MEMORANDUM

From:	Lindsey Abbott Tree & Landscape Officer		
Service	WBC Landscape and Trees	App No:	260497
Address:	The Forest Comprehensive School, Robin Hood Lane, Winnersh, Wokingham, RG41 5NE.		
Proposal:	Full application for the proposed installation of low-carbon heating and hot water systems comprising air-to-water heat pumps, air-to-air heat pumps, and water-source heat pumps, together with associated enclosures, infrastructure, plant and control systems and landscaping, following removal of existing gas-fired heating and hot water infrastructure.		
Type of Development:	Minor All other developments		
Site Visit Made:	No

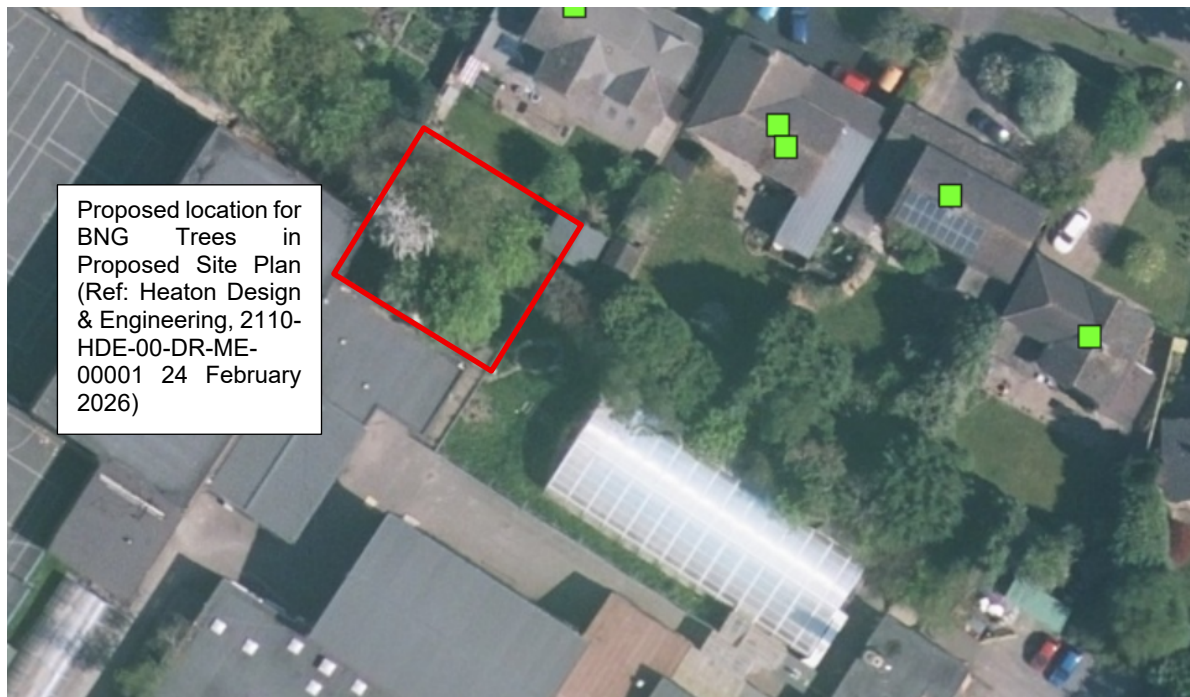
According to the various plans, two tree stumps will need to be removed to accommodate a new path. A category U single tree and category C group of trees are also recommended for removal in section 6.1 of the AIA – T9 Birch (dead) and G14 Sycamore (inappropriate location). These works are not required for the development and the Officer has no objection to them being carried out. Six new trees are proposed for installation to fulfil the BNG requirement according to the Proposed Site Plan. These trees have been located on top of existing trees according to aerial maps. Additionally, these proposed trees have not been specified in the plan (species, size etc) and have been space too closely. The Officer would like revised information about these trees in the form of an amended Proposed Site Plan. See images below.

Above and immediately below: internal ESRI mapping which shows existing trees in this location. The Tree Protection Plan also shows existing trees in this location.
